Exmouth Shellfish No Deterioration SW_ND AMP7 Projects

South West Water Technical Report June 2022

Phear Park SPST_PSCSOEO_Exmouth (WINEP ID 7SW200871)

Maer Rd SPS_CSO_Exmouth (WINEP ID 7SW200711)

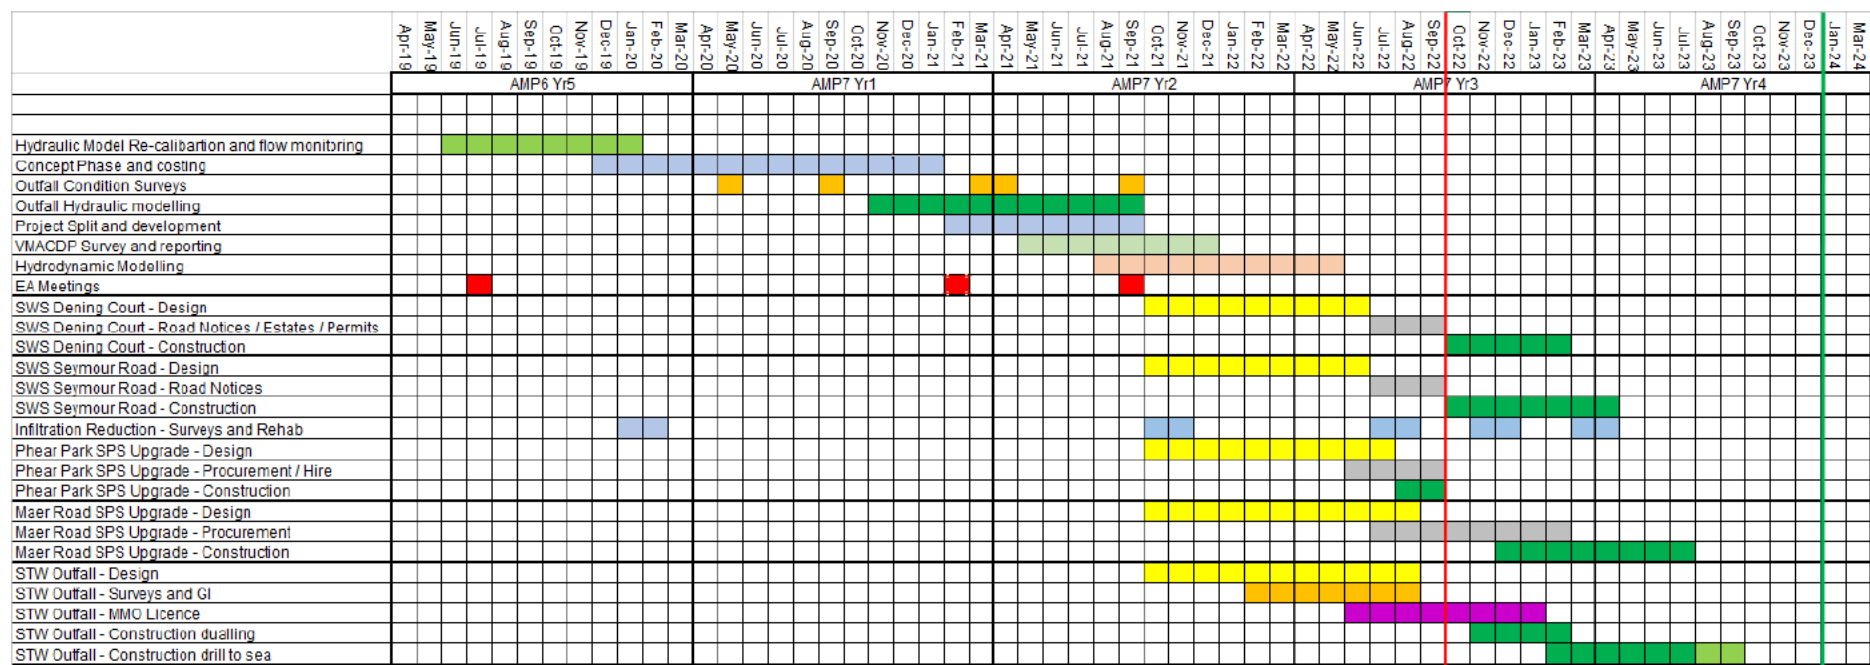
5. Your letter says that SWW has looked at alternative solutions over the last 18 months. Please provide further evidence to explain why options analysis did not take place sooner (after our November 2018 letter).

We apologise if any confusion has been caused by our previous letter. Various stages of design development have taken place after your November 2018 letter, as detailed above and shown in Figure 9. The last 18 months have more heavily involved the Engineering Delivery teams as opposed to Asset Management / Programme Development Teams.

Figure 10 – Beacon Point E.Coli monitoring results⁴

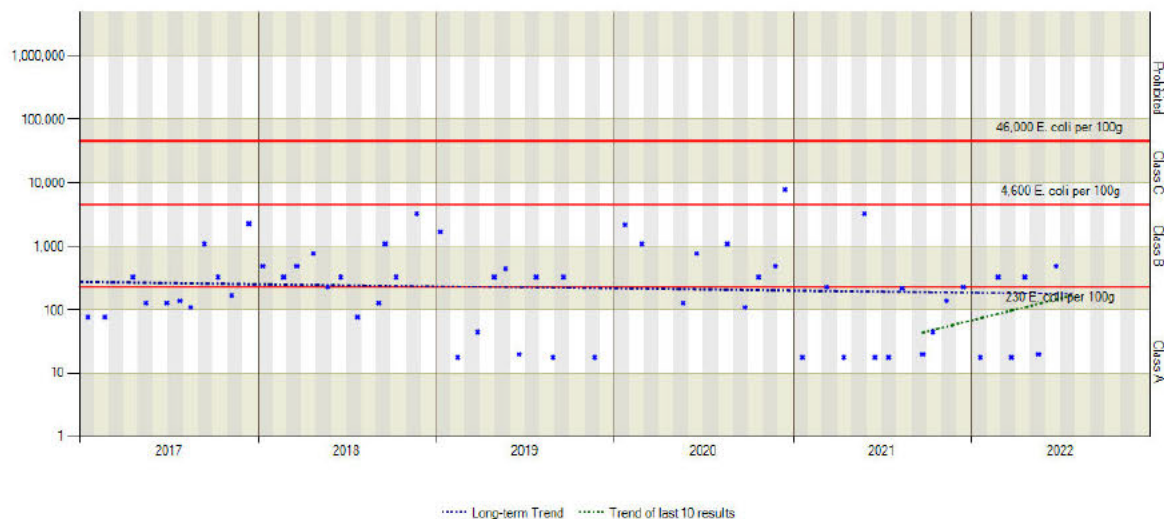
2. Whilst we support sustainable, long-term solutions, legislative requirements must be met. In our letter of 7 November 2018, we were clear that 'The revised deadlines must be met due to legal obligations. However, because of remaining infraction risk, steps should be taken to deliver the measures within the shortest time possible and definitely no later than September 2022'. Further delays to 2023 will be in breach of regulations to prevent deterioration at shellfish waters. Please set out how you plan to mitigate for any impacts on the local shellfish economy.

Reference section 8

The long term trend for the Beacon Point monitoring point suggest an improvement in the E.Coli levels. There has been improvement in the C gigas and Exe Mytilus spp Classification from 2018 to 2021. The area from River Kenn to Starcross has improved from Prohibited to Class B, which may be due to the installation of final effluent UV at Kenn and Kennford STW. The area from Starcross to Dawlish Warren has improved to Long Term B.

With the general improving trends shown above, it is not anticipated that the addition 15 month delay in delivering the Maer Road PS CSO element of the works with cause the shellfish waters to deteriorate, and hence there will be no impact on the shellfish economy.
